MICE hydrogen system

CM41

Review

Relief circuit repair

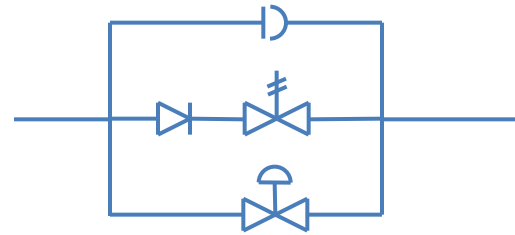
- First proposal was to remove the relief valve entirely and replace the burst disk assembly with a vacuum-compatible one
 - May have caused an unacceptable increase in line impedance during catastrophic boil-off scenario
- Current proposal:
 - Discovered that burst disk assembly can be made leak-tight through retrofit of seals (were graphite spiral gaskets, now aluminium KF-style seals)
 - A leak-arresting check valve will be placed upstream of the relief valve only

Relief circuit calculations

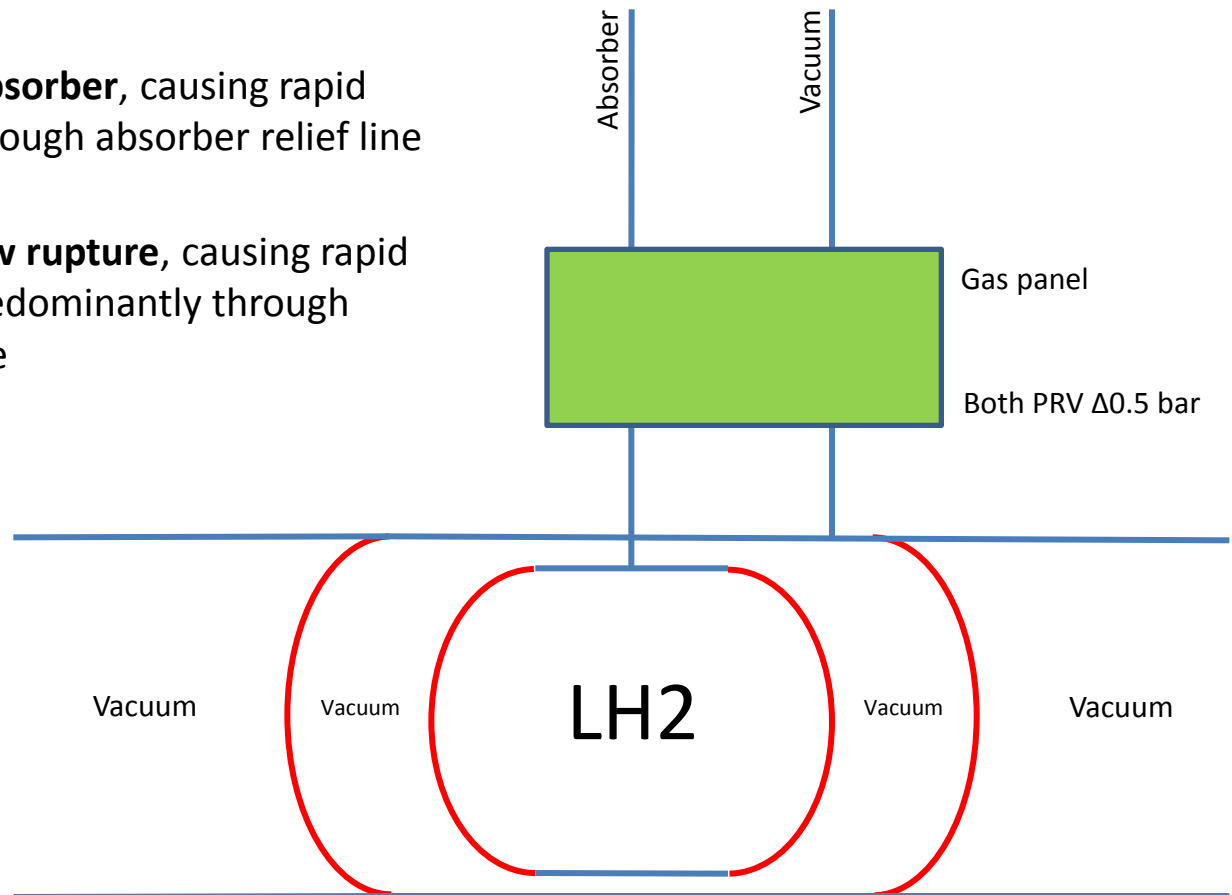
- Two failure scenarios
 - **Heat load into absorber**, causing rapid boiling of LH2 through absorber relief line
 - **Absorber window rupture**, causing rapid boiling of LH2 predominantly through vacuum relief line
